FIXED BEAM ANCHOR - INSPECTION NOTICE (FOR SALT-WATER/CHLORIDE/SULFIDE ENVIRONMENTS)

The DBI-SALA Fixed Beam Anchor is an anchorage connector for a personal fall arrest system. It is designed to be attached to an I-beam. Capital Safety's user manual warns about "Environmental Hazards" and that certain chemicals and corrosive environments may damage the equipment.

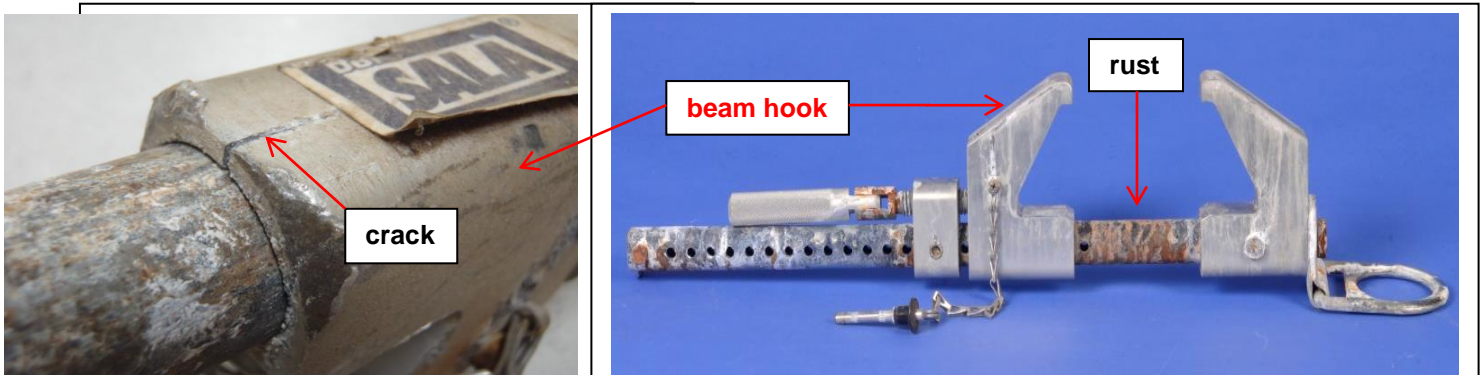
Capital Safety has become aware that the service life of the beam hooks identified in the images below (in red font) may be impaired by stress corrosion cracking when the anchor is exposed to salt-water or other chloride or sulfide-containing environments.

- 1) have the units visually inspected by a competent person; and
- 2) if **any** corrosion, pitting or cracking is found on the beam hooks or the support tube (see illustrations below), remove the unit from service and return via your supplier/distributor to Capital Safety for evaluation and potential replacement under warranty at Capital Safety's reasonable discretion and expense.

- 3) if **no** corrosion, pitting or cracking is found on the beam hooks or the support tube, the units are safe to remain in service provided they are inspected every 90 days and removed from service if **any** corrosion is found anywhere on the unit.

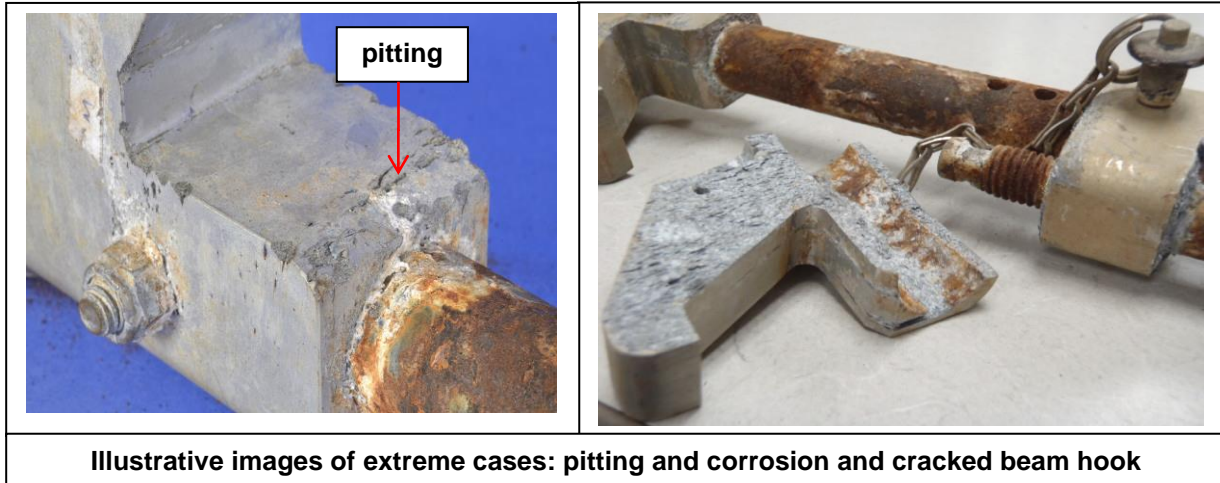
In extreme cases, the integrity of the beam hooks can be severely compromised to the point of failure by stress corrosion cracking as seen in the photographs below:

Since becoming aware of this issue, Capital Safety has changed the metal alloy of the beam hooks to make them resistant to stress corrosion cracking in salt-water or other chloride or sulfide-containing environments.

Capital Safety has also revised its User Manual concerning inspection as follows: ***“IMPORTANT: Any observed corrosion or rust on the anchor is a potential safety concern because it can weaken the product and create a risk of injury or death to workers. Any anchor showing signs of corrosion or rust should be removed from service immediately.”***
